ENVIRONMENTAL REVIEW TEAM REPORT

IVY WOODS SUBDIVISION
WOODBURY, CONNECTICUT

JULY 1979

The Town of Woodbury, Connecticut is presently reviewing a preliminary application for subdivision of ± 300 acres of land. The subject site is located in the northcentral portion of town, just west of Flanders Road.

FIGURE I. SIMPLIFIED SITE PLAN

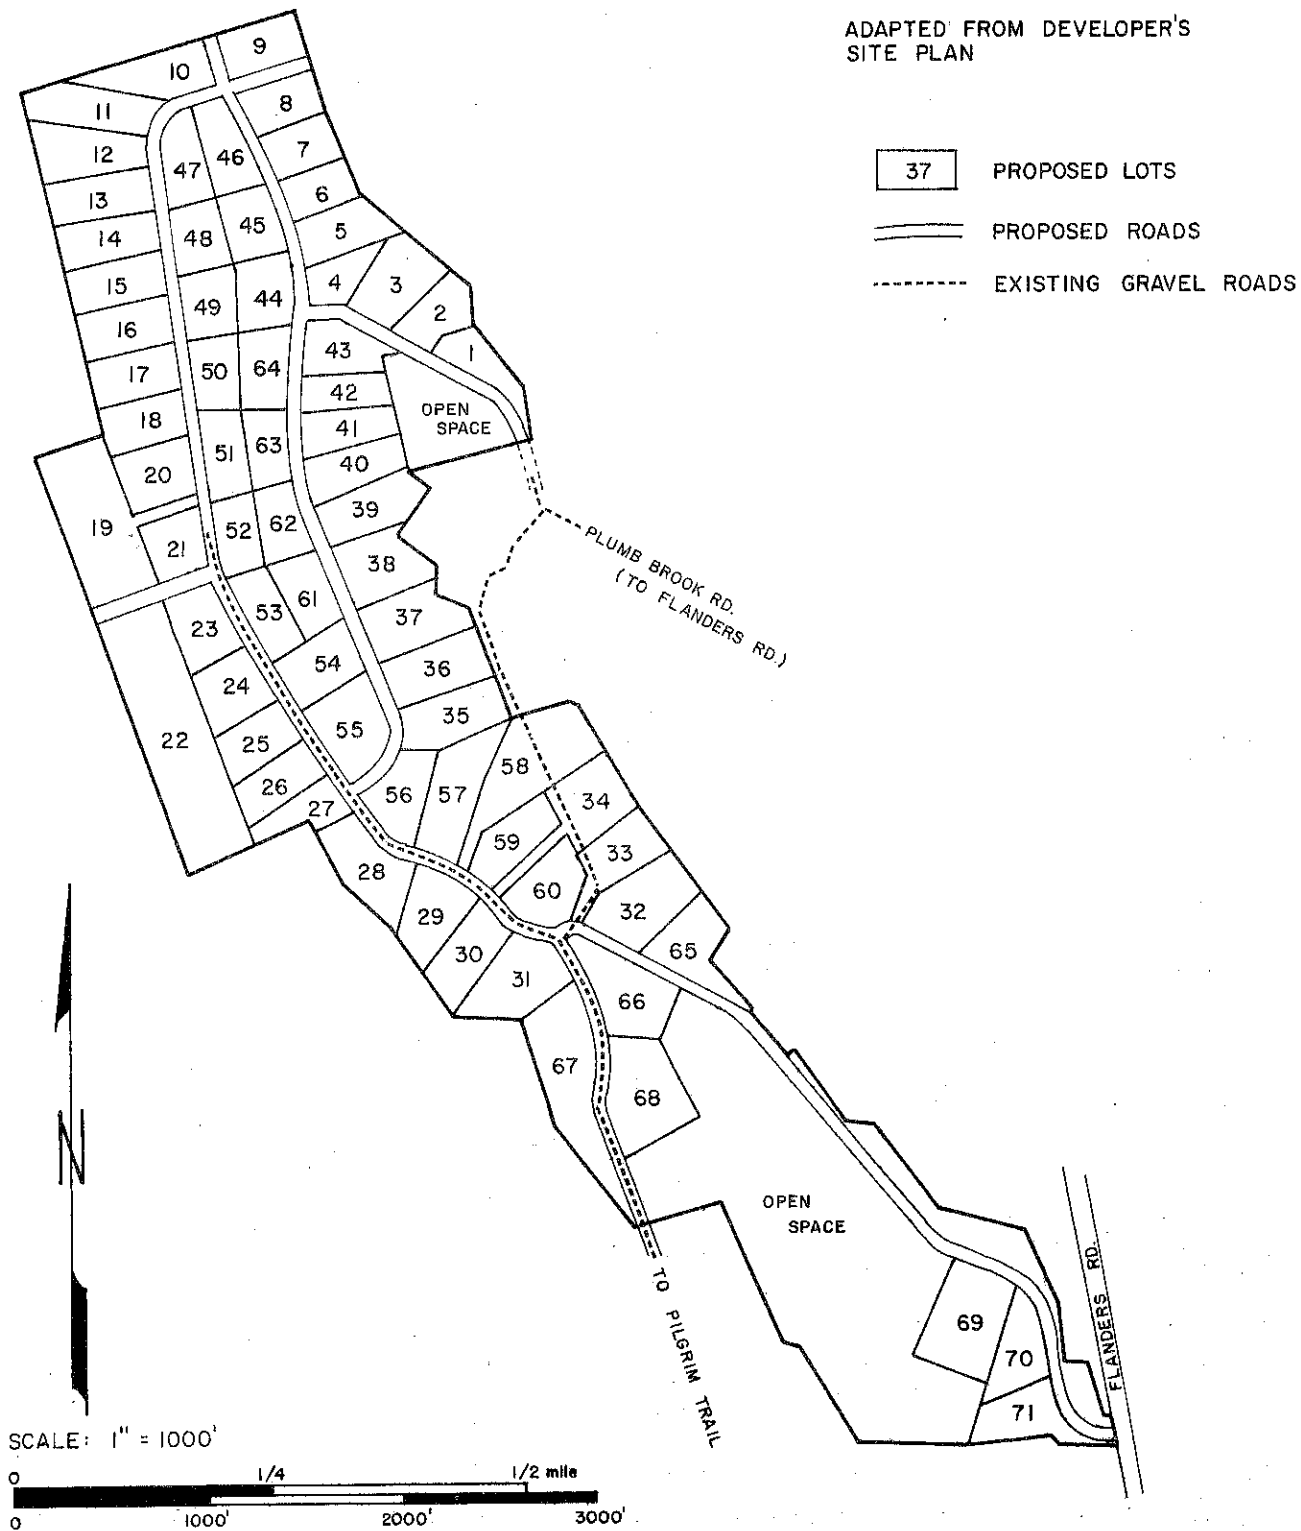
Preliminary plans for the proposed "Ivy Woods Subdivision" call for 71 building lots (2+ - 9+ acres in size) and ± 60 acres of open space (see Figure 1). An interior road network of ± 16,200 linear feet is being proposed to service the lots with access via Pilgrim Trail, Flanders Road, and Plumb Brook Road. Domestic water supply is proposed to be provided by on-site wells. Sewage disposal is proposed to be handled by septic systems.

- . Preliminary subdivision plans indicate that 27%+ of the proposed interior road network is in excess of the desirable maximum gradient of 8% according to AASHO standards. Additionally, many proposed vertical curves are insufficient in length to allow safe stopping sight distances. The project is expected to generate 750+ trips onto these local roads daily upon completion.

- . All three of the proposed access points to the project site have restricted sightline distances which will impede safe and efficient traffic flow.

The preliminary subdivision plans call for + 16,200 feet of interior roads connecting to 3 access points at Flanders Road, Flumb Brook Road and Pilgrim Trail (see Figure 1). These plans also show 27%+ of the proposed interior roadways in excess of the desirable maximum gradient of 8% according to the AASHO* standards. There was also an additional 17%+ in excess of the town's design standard maximum grade of 6%. Additionally, many proposed vertical curves are insufficient in length to allow safe stopping sight distances. It is recommended that the developer's designer reduce the grades and unnecessary vertical curves to minimize the effect on the stopping sight distances. The project is expected to generate 750+ trips onto these local roads daily.

FIGURE 2.
TOPOGRAPHIC MAP

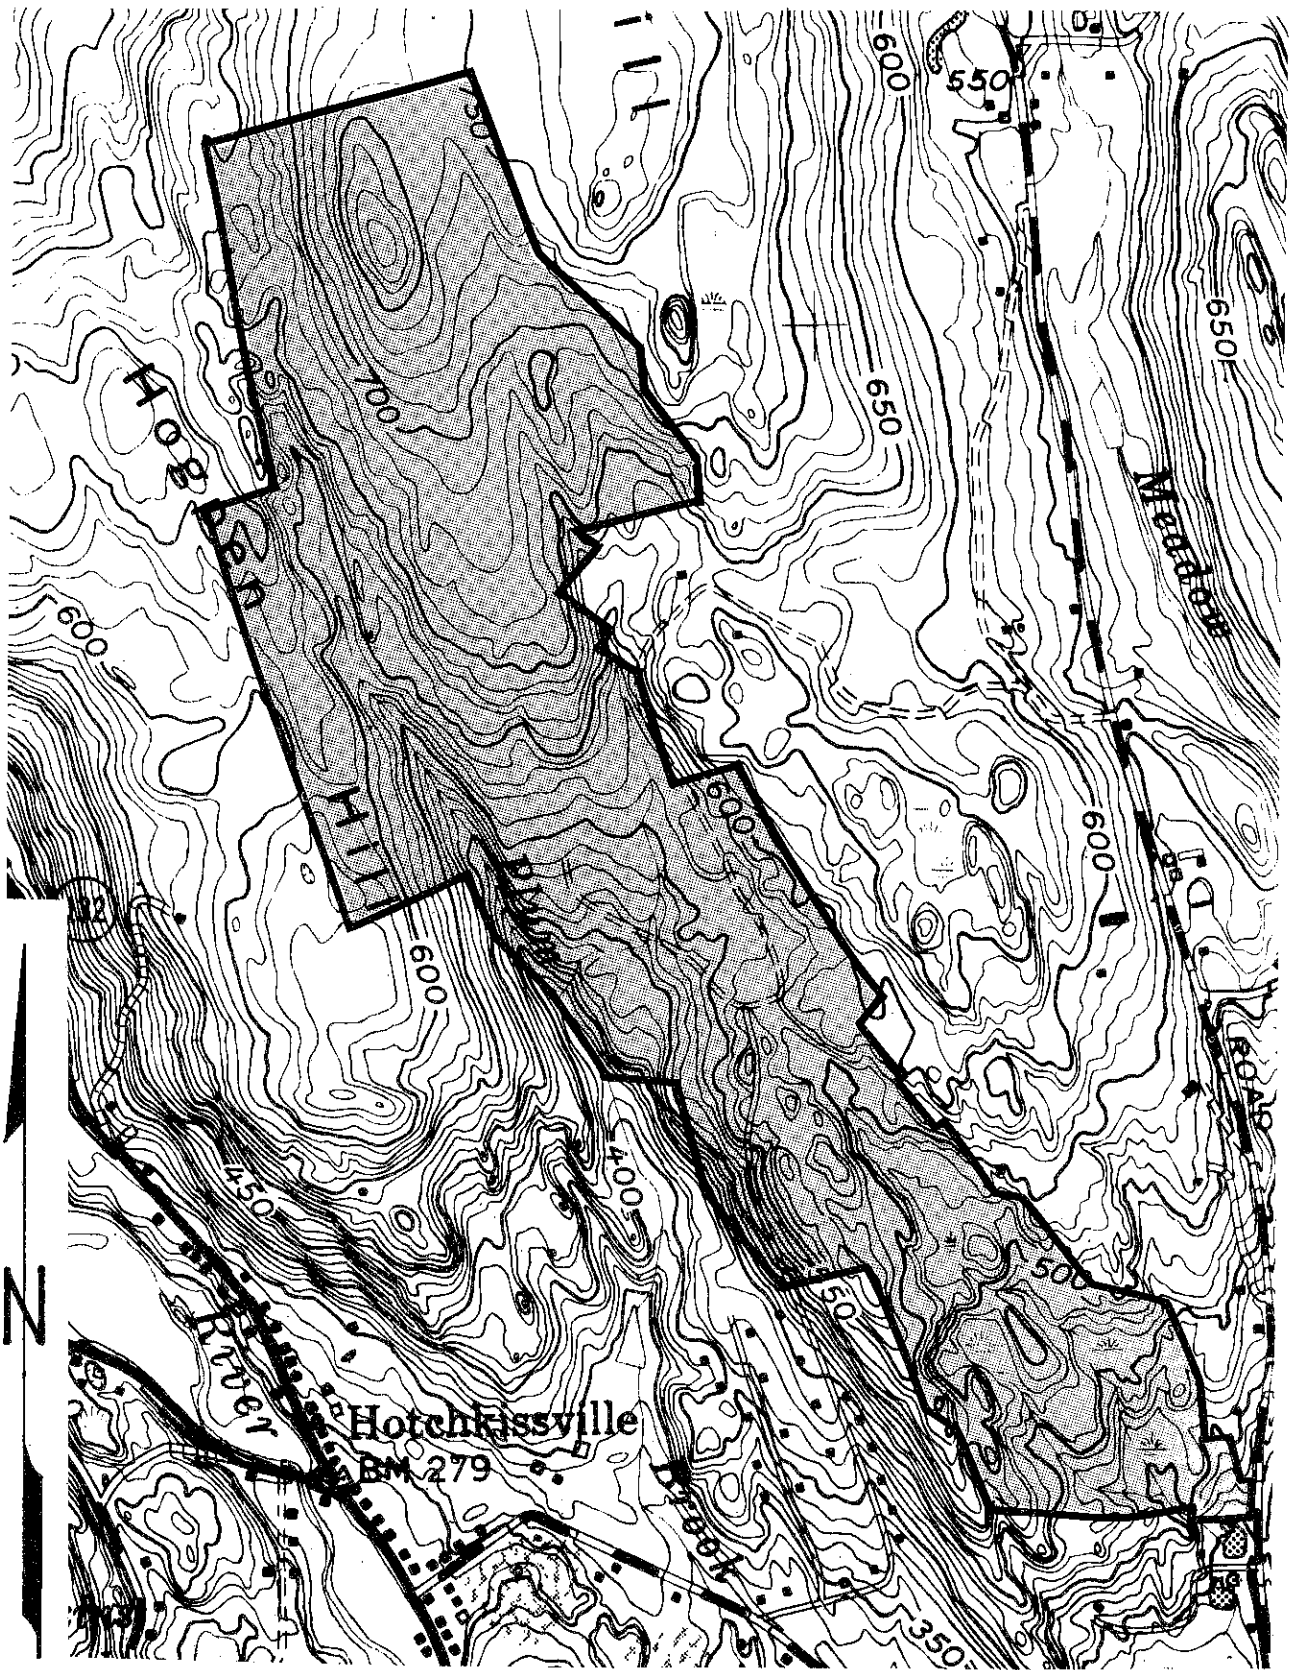
In general the elevation of the site increases from south to north. Slopes vary from nearly level to almost vertical with minimum and maximum elevations of 350 feet and 780 feet, respectively. The general slope classification of the site is moderate to steep (see Figure 2).

FIGURE 6.
MAJOR SOIL TYPES

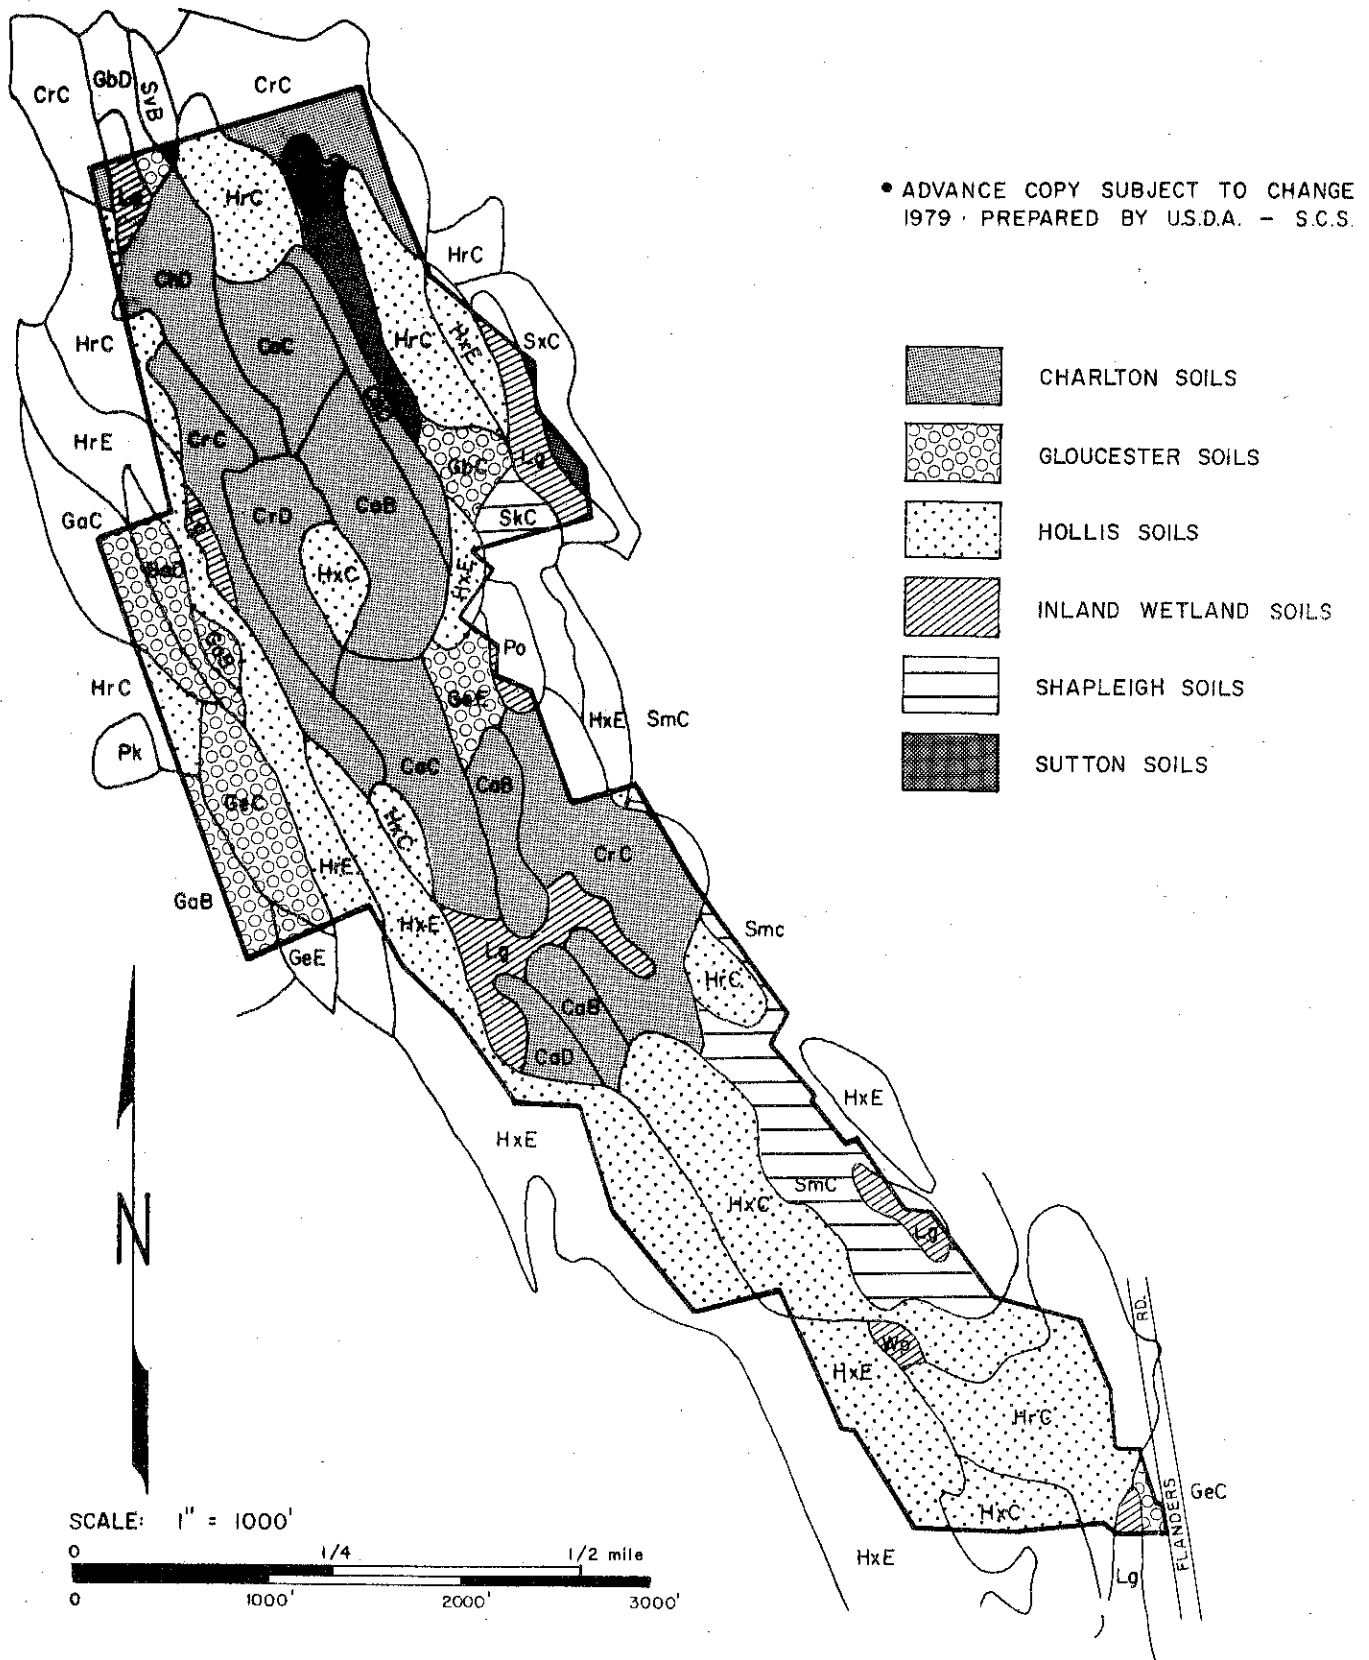
Basically there are eight major soil types on the property (see Figure 6). A brief description of each of these soils is presented below (refer to Figure 6).

The major soils limitations for the proposed development center on the subsurface geology of the area. As shown in Figure 4, bedrock is within a few feet of the soil surface on a large percentage of the site (approximately 42%). This shallow to bedrock condition represents a severe limiting factor for implementation of the proposed project. Although some inclusions of other soil types may be encountered within these shallow to bedrock areas which are more favorable for development, the shallow to bedrock areas themselves will likely require substantial and expensive modifications to accommodate the proposed development. For example, blasting could be necessary for basement excavations and road construction; and costly engineering may be required for septic system installation.

Soils are more acceptable for homesite development in the north and central portion of the property. These soils, predominantly of the Charlton and Gloucester Series, pose few problems for homesite development, septic system installation and road construction. Only those sites which have steep slopes (8% or greater) or numerous large stones pose moderate to severe problems.

FIGURE 7.

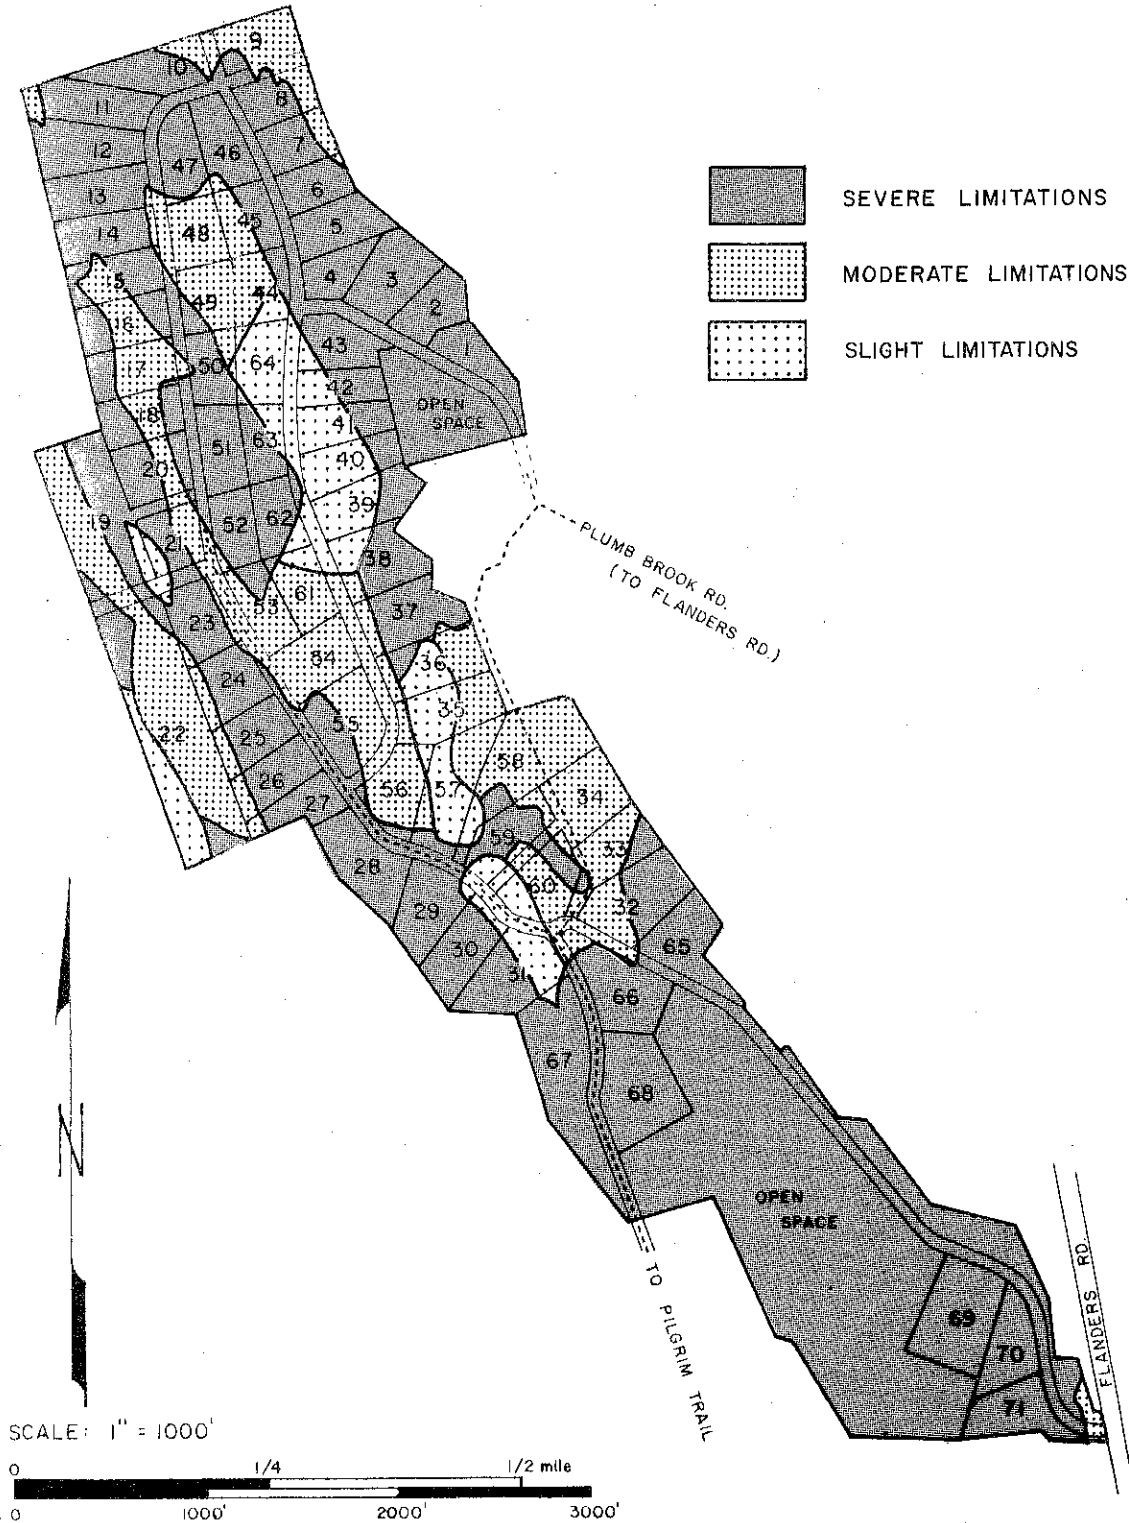
A summary of the suitability of the existing soils to support the proposed land use is portrayed in Figure 7. It should be noted that although much of the site presents severe limitations for residential development, this does not necessarily preclude use of the site for this purpose. It does imply that expensive and extensive modifications would be necessary to assure an environmentally sound development.

Approximately 60 acres of this tract are proposed for open space. Much of this land is characterized by steep slopes, wetlands, or shallow to bedrock conditions. While it is true that these are environmentally sensitive areas and should be protected, it is also true that the potential of this land for woodland products, wildlife habitat management and recreational use is quite limited. The most suitable land on the parcel for recreational use, forest management and wildlife habitat management is the same land most suitable for homesite development (see Figure 7).
